IMMIGRATION HOLDING CENTER, LAVAL

PWGSC project: R.082963.001

ADDENDUM A-04

CONTENU **AJOUT FINI « U »**

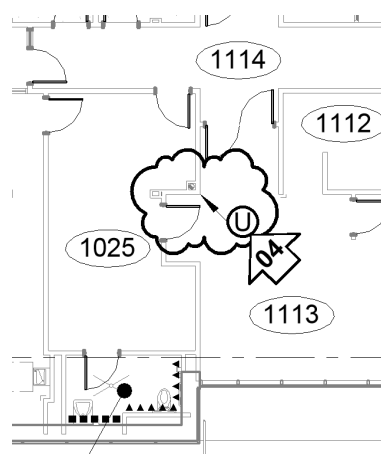
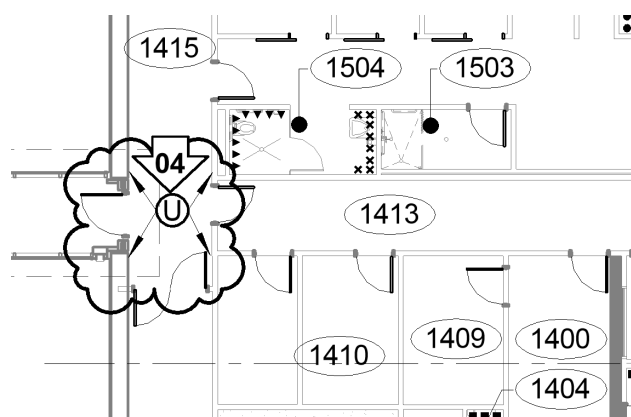
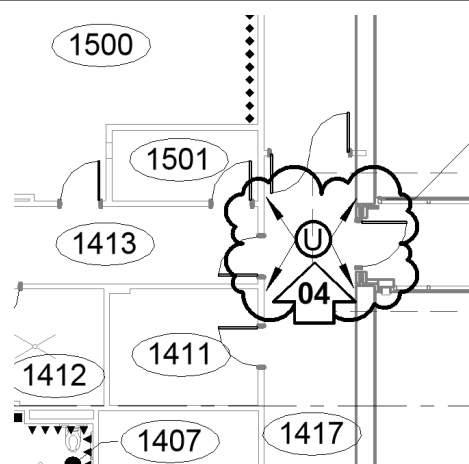
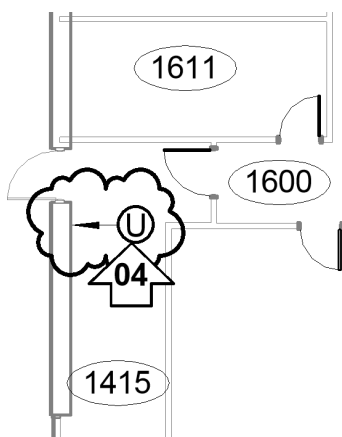
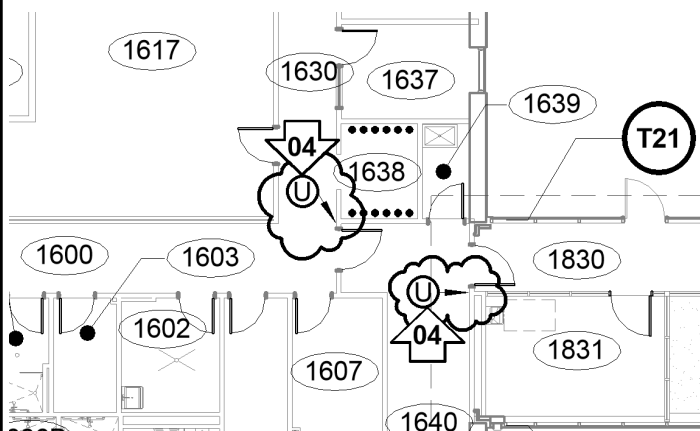
1. **ADD** reference of finish " U " (See drawing extracts, sheet **01** following this addendum)
2. **CANCEL** wood panels finish for rooms 1104 and 1113.
(See drawing extracts, sheet **02** following this addendum)

CONTENU
MODIFICATION LÉGENDE DES TYPES DE FINIS /
SUPPRIMER PANNEAUX DE BOIS LOCAUX 1104 & 1113
MODIFY LEGEND - TYPES OF FINISHES / CANCEL WOOD
PANELS IN ROOMS 1104 & 1113

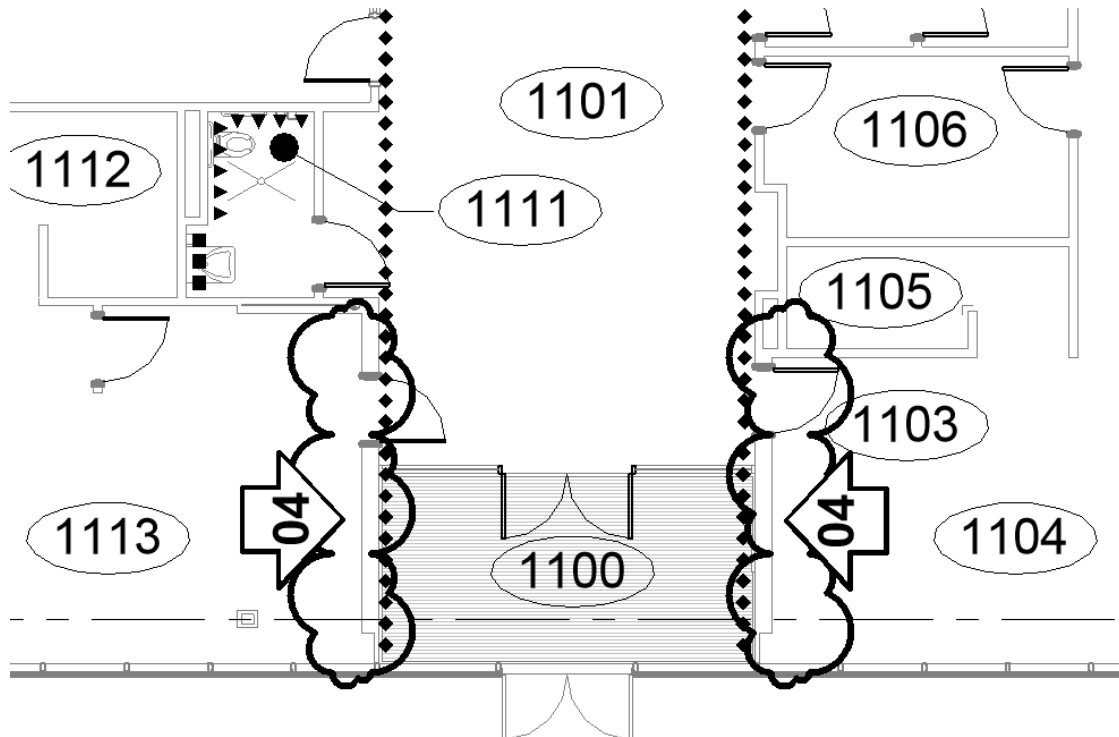
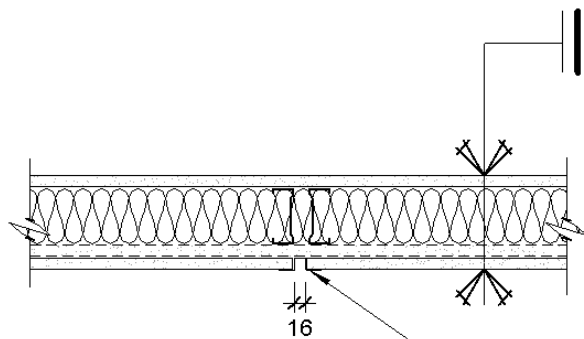
1. **ADD** type of finish " U: FINISHING GYPSUM 16mm U-TRIM. SEE DETAIL 628 ON SHEET A603. "
(See drawing extracts, sheet **02** following this addendum)

1. **MODIFY** the finishes of the rooms 1204, 1417, 1638, 1852, 1870 et 2028.
(See drawing extracts, sheet **02** following this addendum)

CONTENU
AJOUT DÉTAIL #628
ADD DETAIL #628

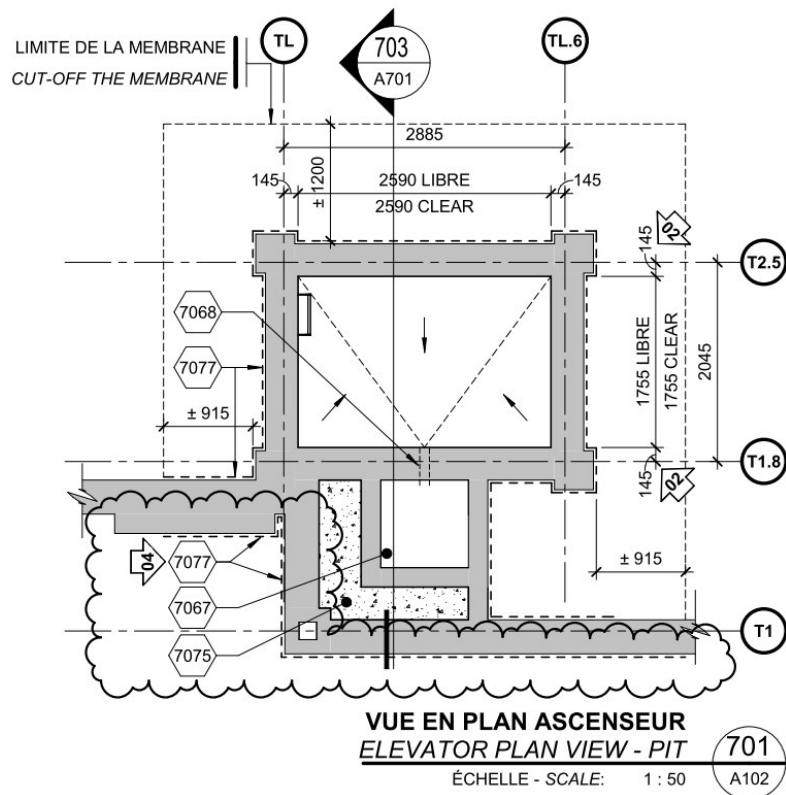
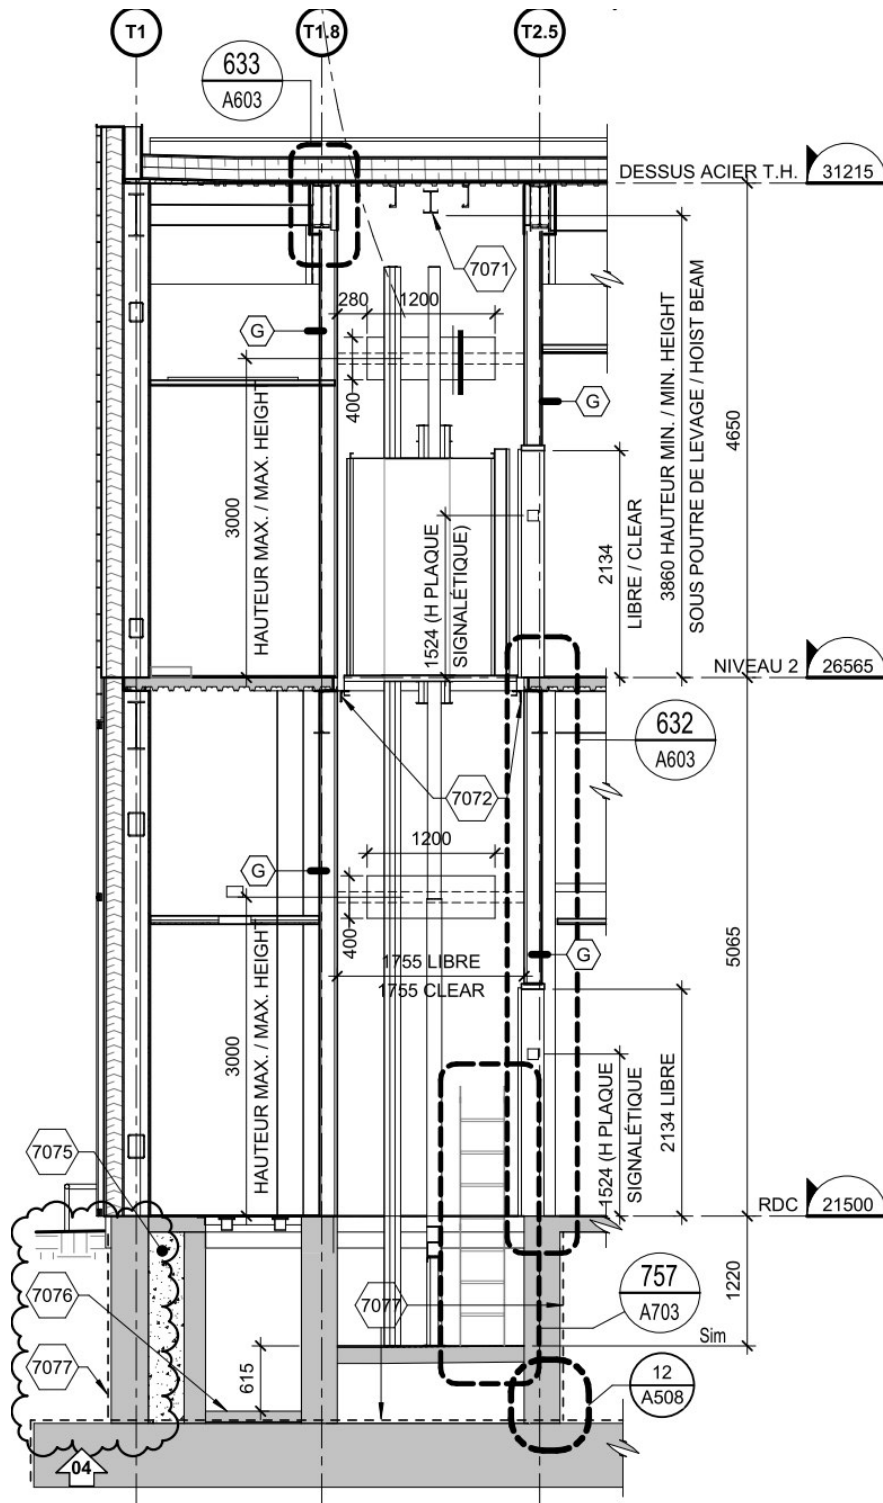
1. **ADD** detail N°628. (See drawing extracts, sheet **03** following this addendum)

MODIFICATION COUPE 703

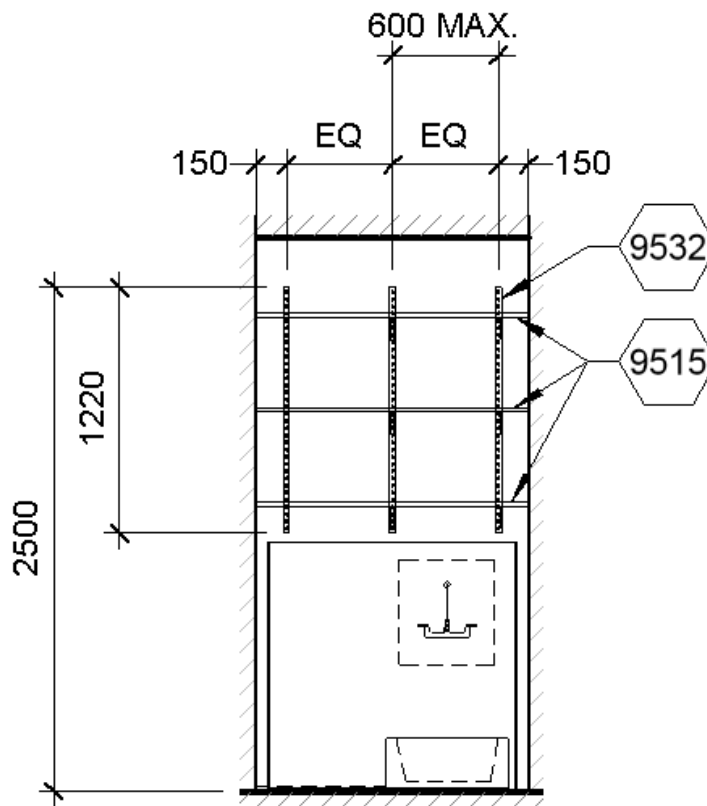
1. **ADD** note 7077 and **ADD** the illustration of the note, an asphalt primer and thermofusible elastomeric membrane, welded on the exterior side of the foundation wall.

CONTENU
MODIFIER TITRE ÉLÉVATION 46

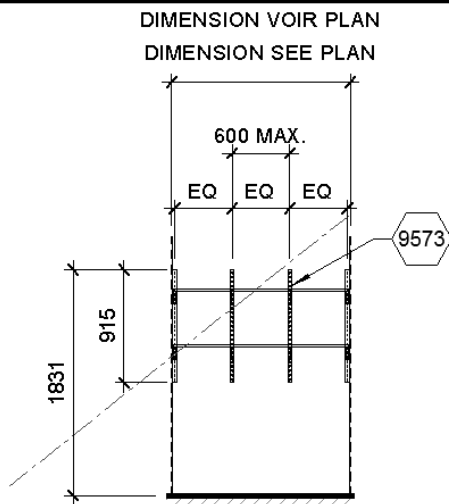
1. **MODIFY** the principal title " ADJUSTABLE SHELVES – 3 " by « TABLETTES AJUSTABLES – 3 ».
(See drawing extracts, sheet **06** following this addendum)

CONTENU
AJOUT TRADUCTION TITRE DÉTAILS 74, 84 & 85

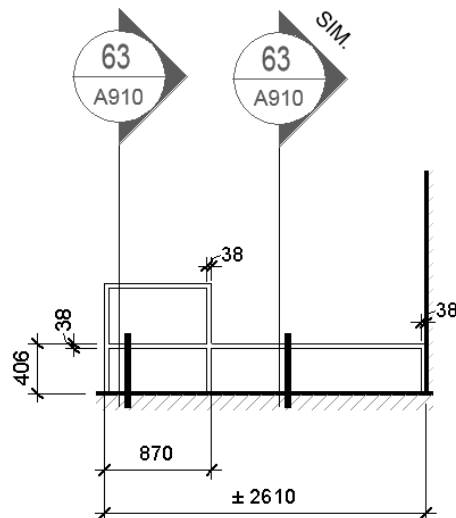
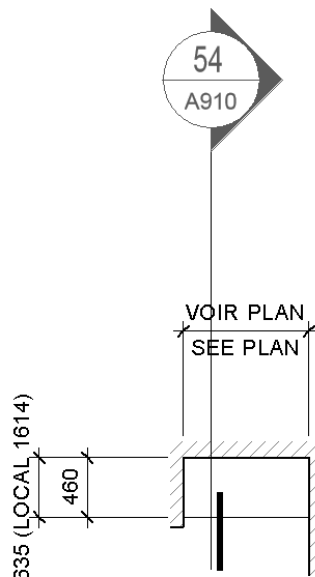
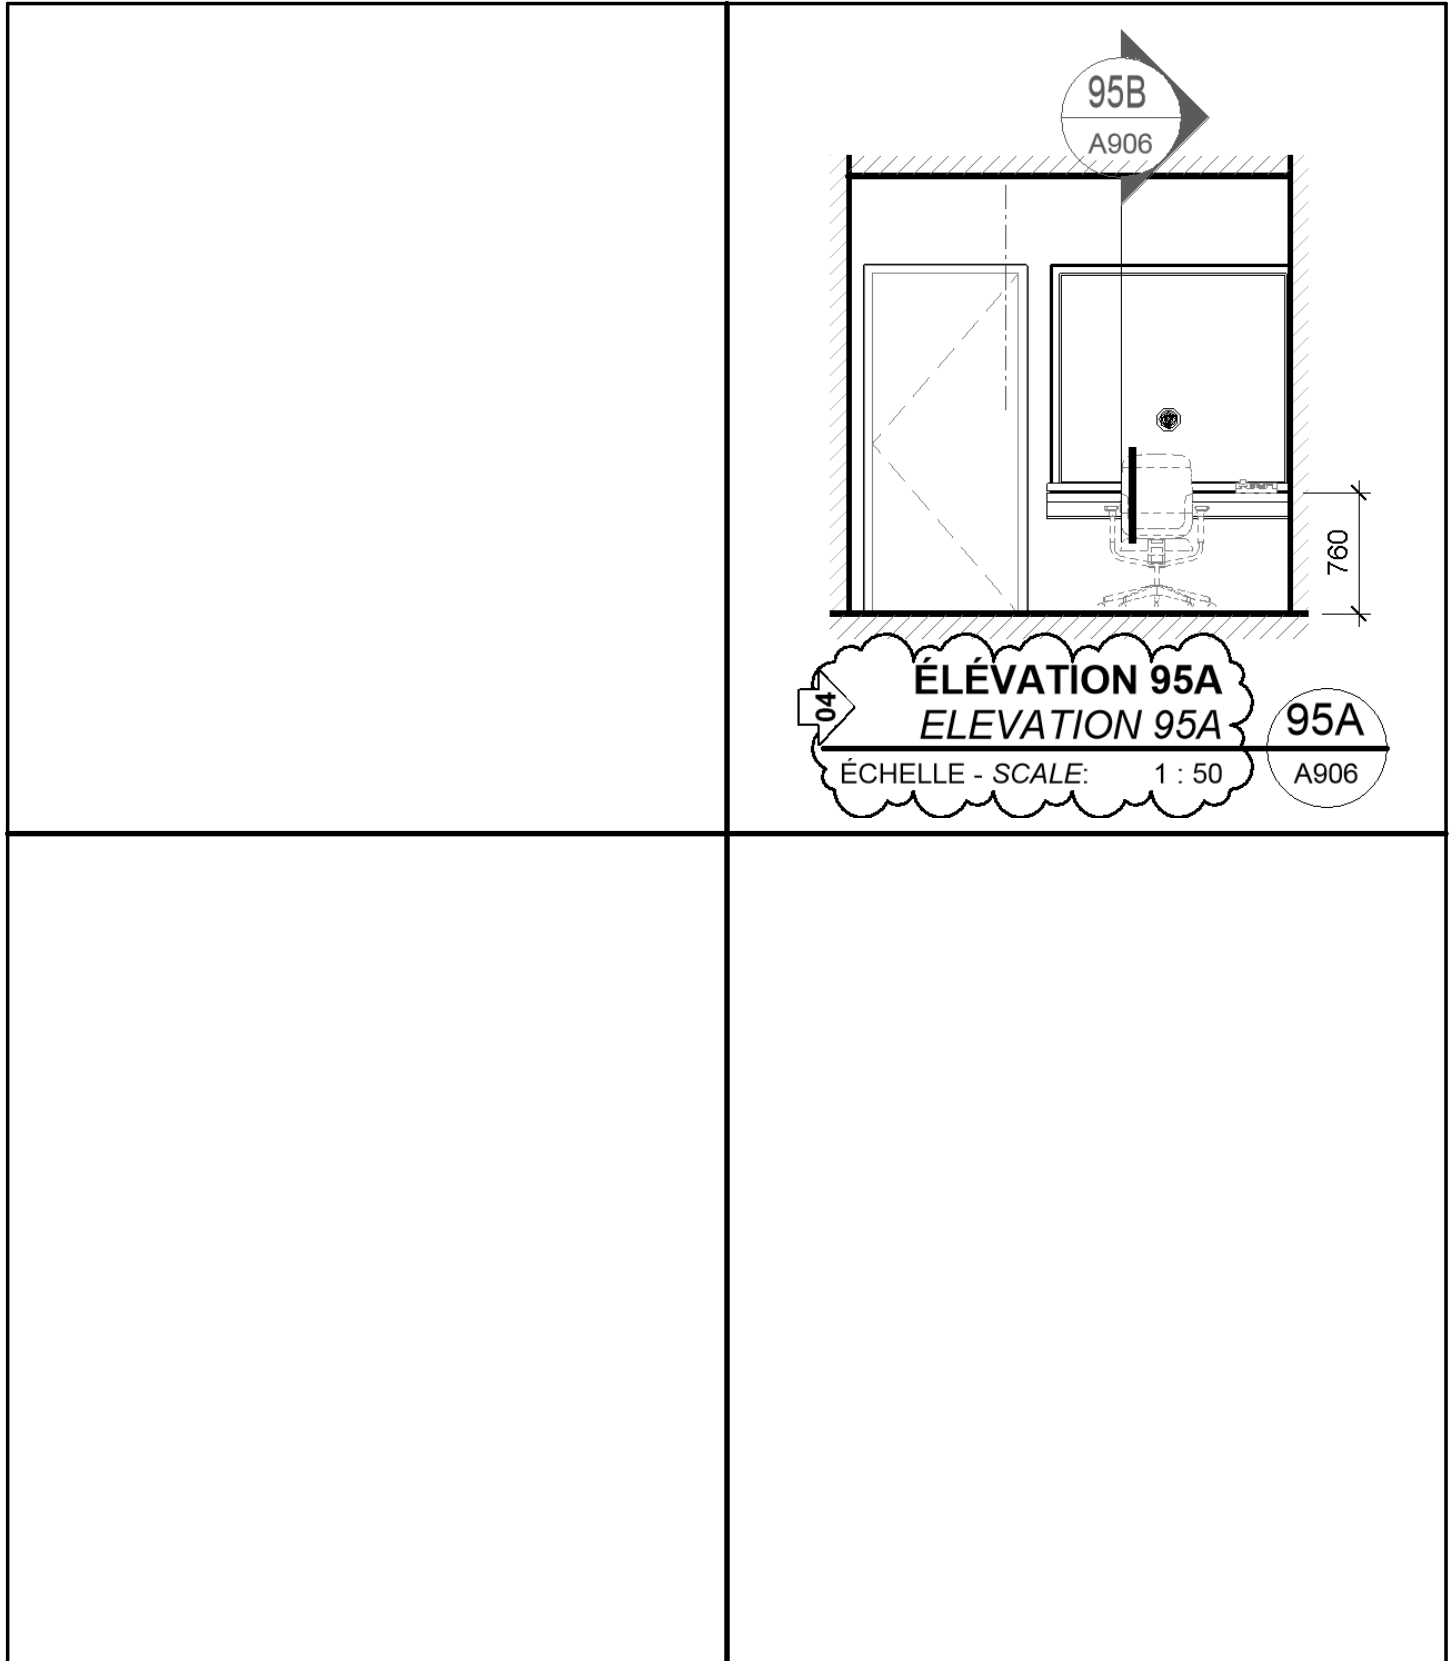
1. **ADD** the translation of the title: " STANDARD COUNTER TOP ".
(See drawing extracts, sheet **07** following this addendum)

1. **ADD** the translation of the title: " FOOTPRINT BENCH ".
(See drawing extracts, sheet **07** following this addendum)

1. **ADD** the translation of the title: " ROBUST SHELVES ".
(See drawing extracts, sheet **07** following this addendum)
